MEETING OF LUCAN AREA
COMMITTEE

TUESDAY 27th NOVEMBER 2012

PART 8 REPORT ON LOCAL GOVERNMENT (PLANNING AND
DEVELOPMENT) REGULATIONS 2001 – 2012

ADAMSTOWN ROAD (R120)
IMPROVEMENT SCHEME

PLAN OF PROPOSED ADAMSTOWN ROAD (R120) IMPROVEMENT SCHEME

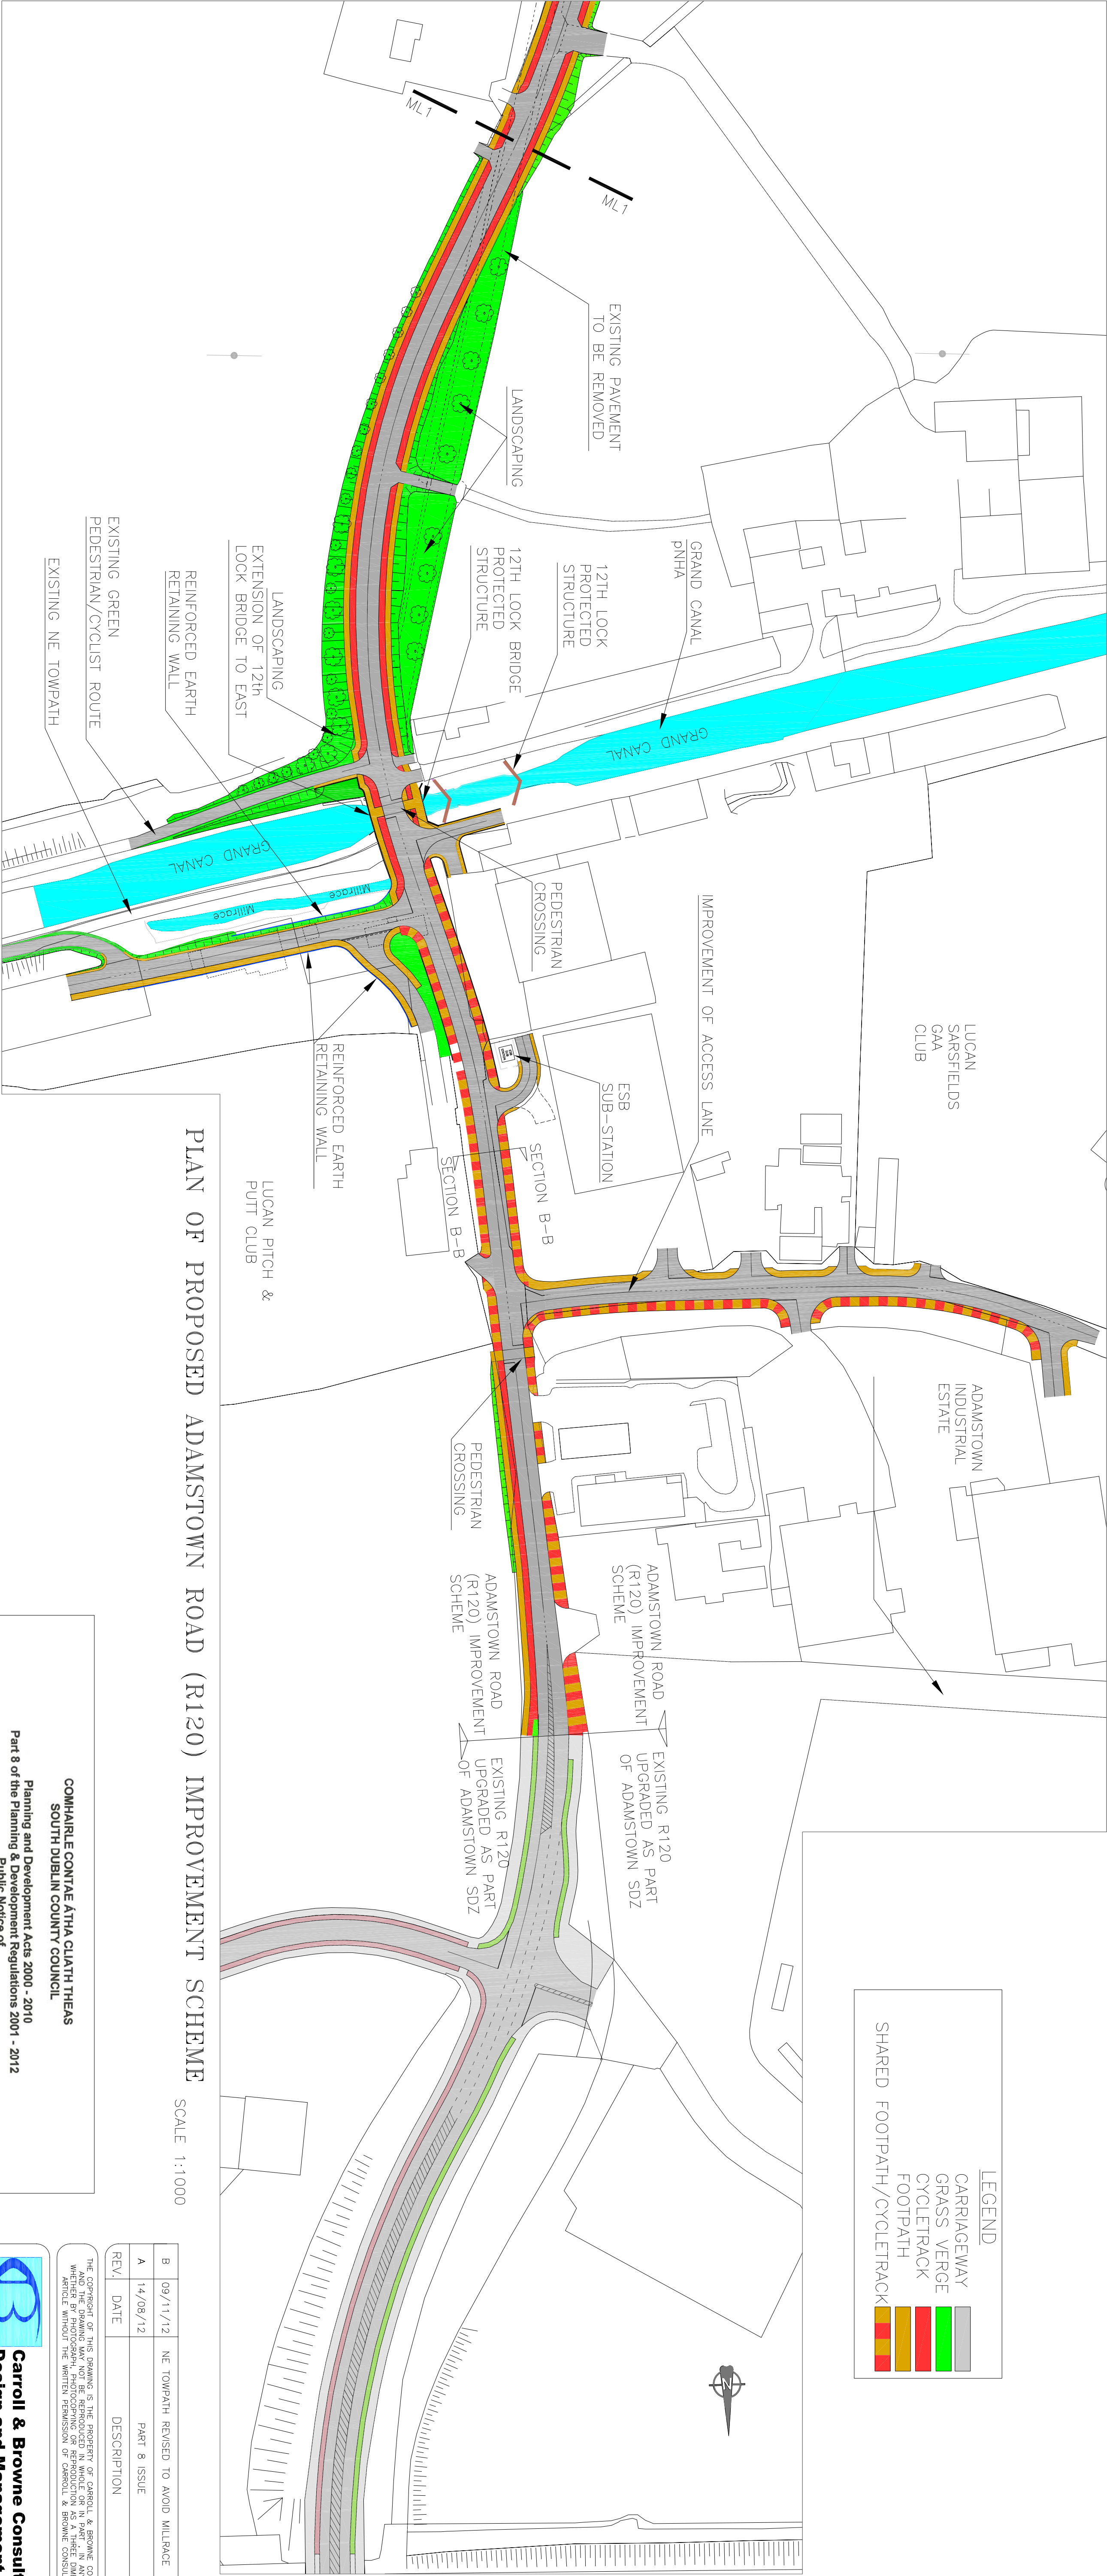
- Although not salmonid the proposal to culvert approximately 70 metres of millrace will reduce the ecological value, biodiversity and visual amenity of the watercourse.
- Have all other alternatives for the route been considered in terms of effects on the mill race and hence the otters and crayfish.
- Culverting of the mill race will disturb the otter and crayfish habitats.
- It would appear that the millrace has a definite degree of ecological merit and biodiversity value. Serious consideration is recommended for a re-design of *‘that section of the proposed design which will destroy the present natural status of the mill race and thus remove habitat of Protected Species and Annex II species of the Habitats Directive’*.

It is proposed to revise the alignment of the access (to the former Univar site and northeast towpath) northwards so as to avoid disturbing the existing millrace. The NPWS is satisfied with the proposed mitigation measure, which ensures that the crayfish / otter habitat in question is maintained.

As a result of the submissions in relation to Issue 10 it is proposed to re-align the proposed northeast towpath in order to avoid disturbance of the canal millrace. There are no other changes proposed to the proposed plan as advertised. This realignment is a localised modification to the proposed plan as a further mitigation measure and would not warrant a further Part 8 consultation process.

- a) Re-alignment of the vehicular access to the former Univar site and northeast towpath in order to avoid the canal millrace.

REV.	DATE	DESCRIPTION	APPR.
B	09/11/12	NE TOWPATH REVISED TO AVOID MILLRACE	SMCN
A	14/08/12	PART 8 ISSUE	SMCN
